SUBJECT: NuScale Power, LLC Submittal of the Approved Version of NuScale Topical Report, "NuScale Control Room Staffing Plan," TR-0420-69456, Revision 1

Subject: Final Safety Evaluation for NuScale Control Room Staffing Plan Topical Report (TR)-0420-69456, Revision 1

“NUSCALE CONTROL ROOM STAFFING PLAN”

Figure A-2.4 Scenario 1 Task Time Ratios

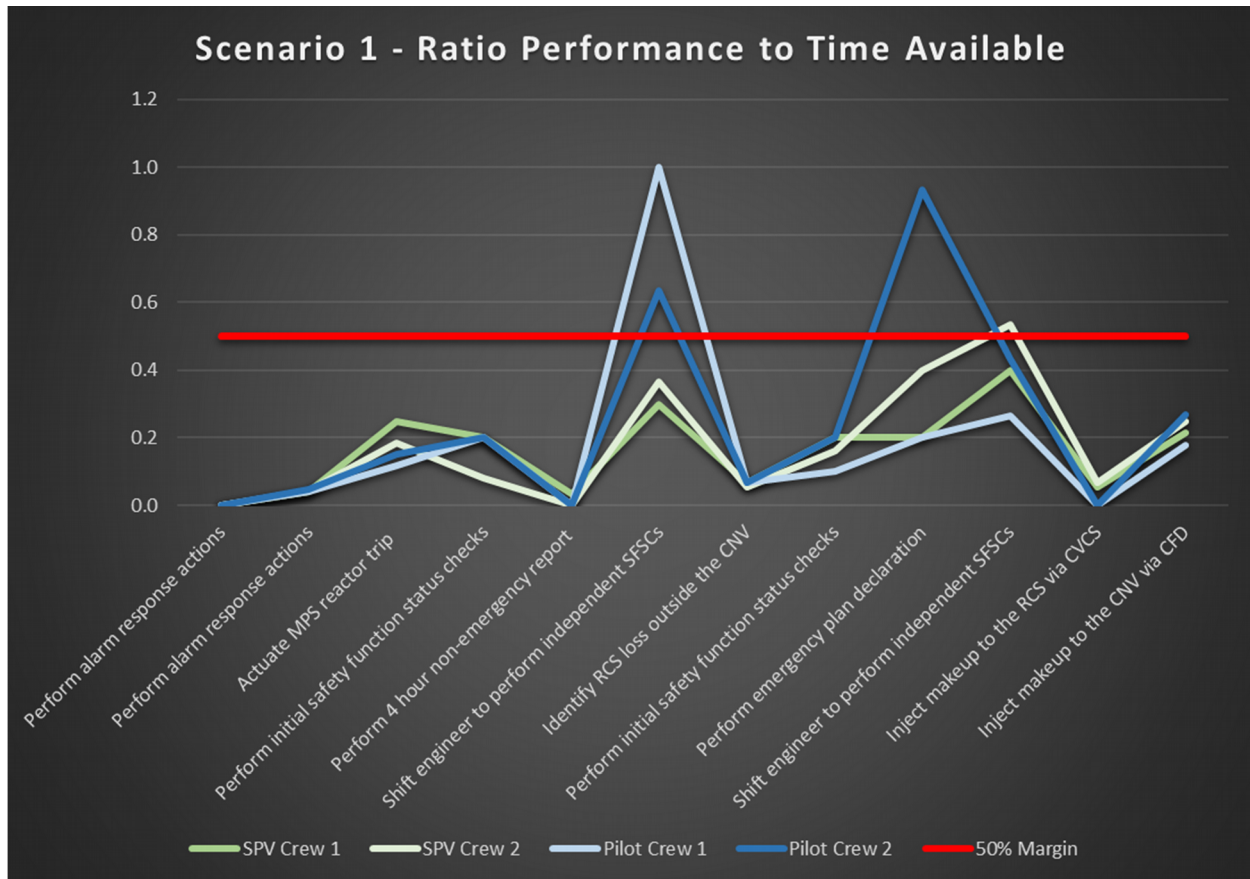
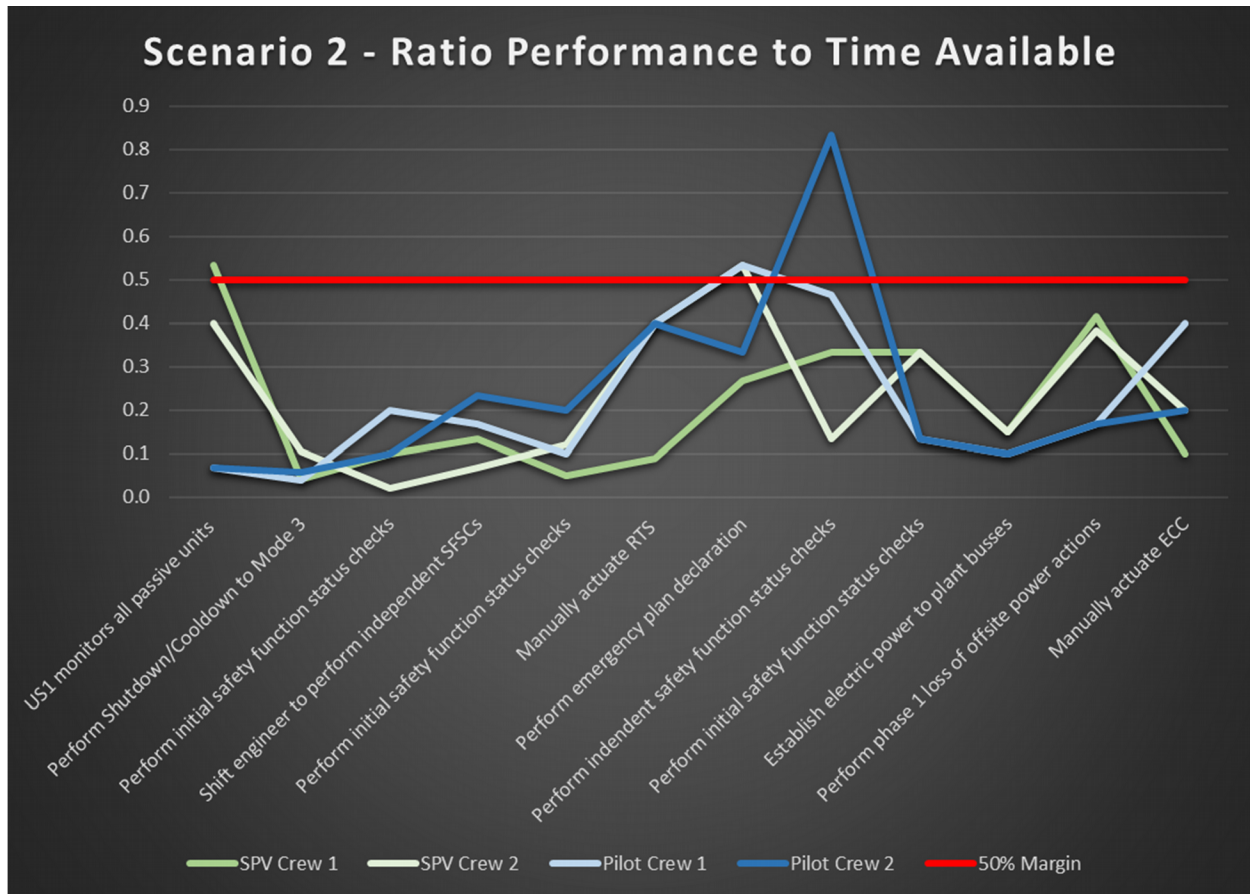
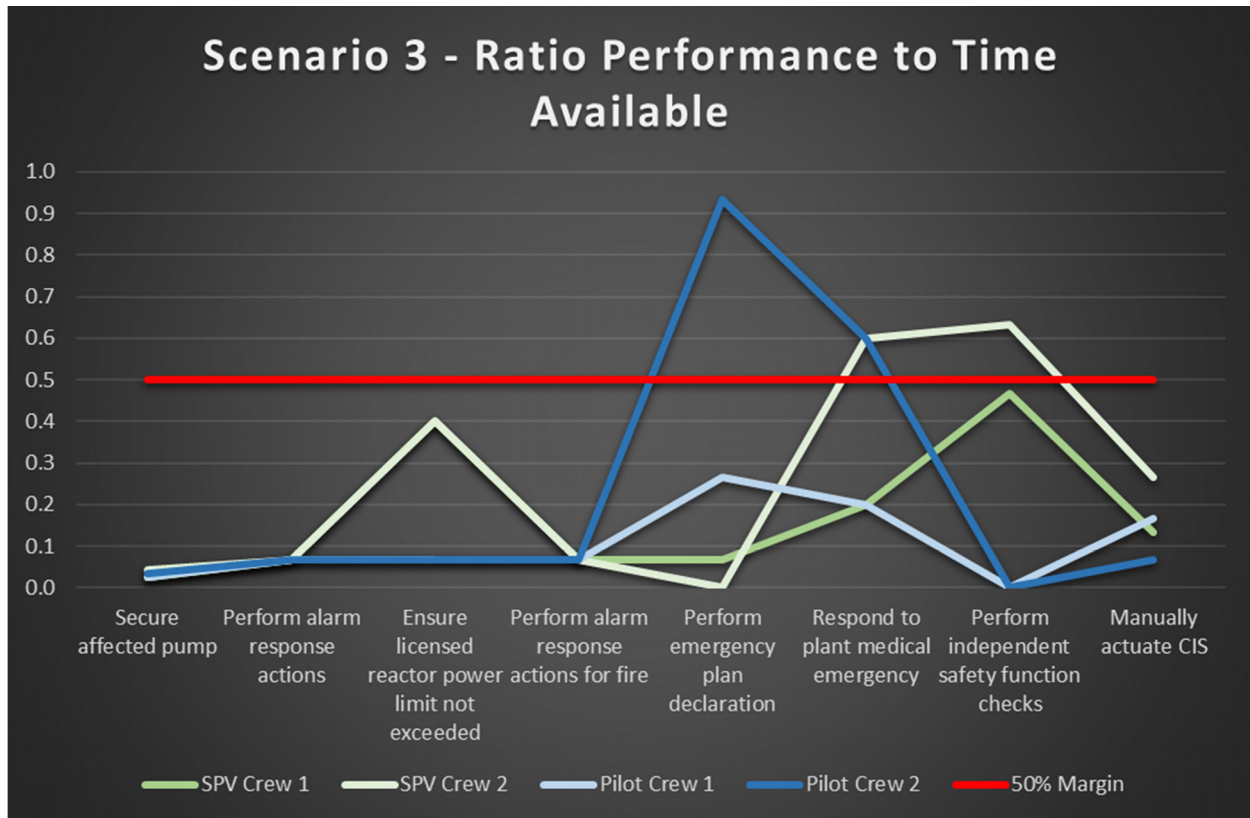
In the response to RAI 9789, Question NTR-13, NuScale stated, "Using the original SPV scenarios for the readiness assessment allowed benchmarking of the results against the SPV results." The response to RAI 9789, Question NTR-13, also shows the results of task performance for the readiness assessment as compared to the SPV task performance results. It states, "The task timing ratios for the three scenarios shows, generally, that the RSPV crew data was consistent with the SPV data with all the tasks were [sic] performed within the allowed time by all crews." The staff reviewed the data provided in the RAI response and observed that all tasks with time as an acceptance criterion were completed during the readiness assessment within the time available.

Overall, the data collected showed that measured tasks were completed within the allowed time for both crews. In some instances one, and sometimes both, of the crews in the readiness assessment had better time performance than the SPV crews.

The task timing ratios for the three scenarios shows, generally, that the RSPV crew data was consistent with the SPV data with all the tasks were performed within the allowed time by all crews.

Figure A-2.1 Crew Workload Comparison

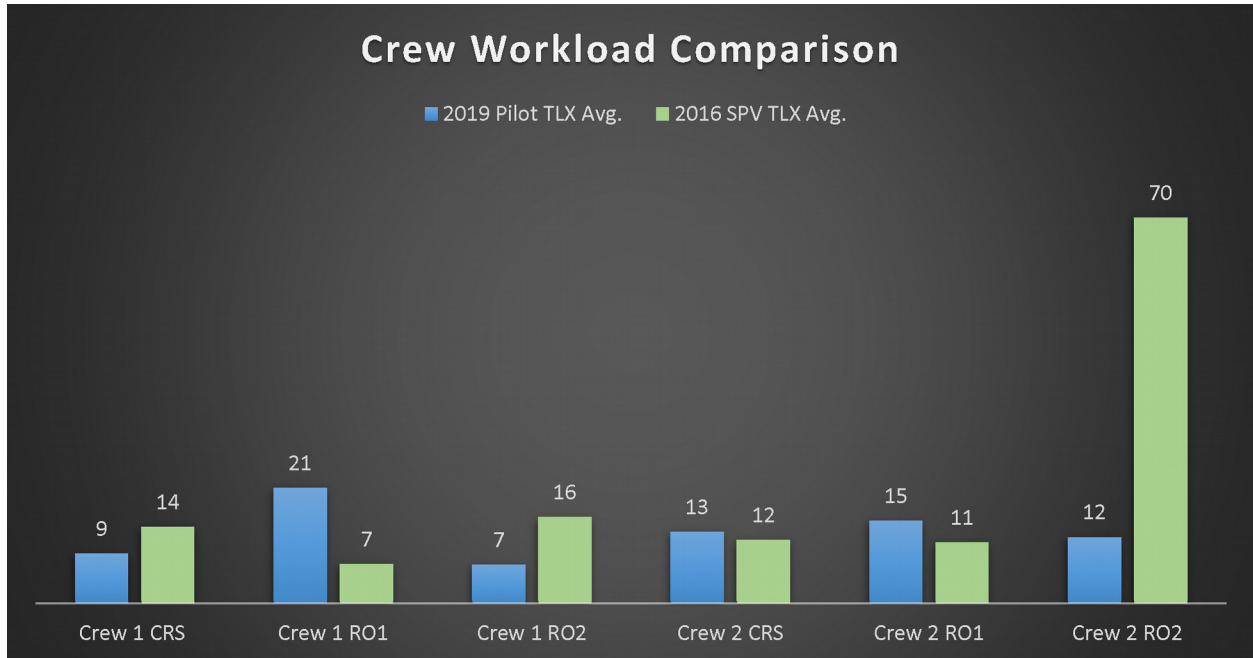
In the response to RAI 9789, Question NTR-13, NuScale also described the workload and SA results for the readiness assessment. The response states, "The average of TLX workload index scores gathered during the RSPV readiness assessment were similar to the 2016 SPV results." The RAI response includes the workload results, which show that, in general, average workload scores during the readiness assessment were relatively low and were generally comparable to those measured in the SPV test. The average SA results were the same as those for the SPV (93 percent), which is relatively high.

The average of TLX workload index scores gathered during the RSPV readiness assessment were similar to the 2016 SPV results.

In general, the measured workload is consistent between the two tests with the exception of RO2 for crew 2. The 2016 SPV results document this self-observed high level on one of the individuals. That individual had a consistently higher scoring baseline in comparison to others.
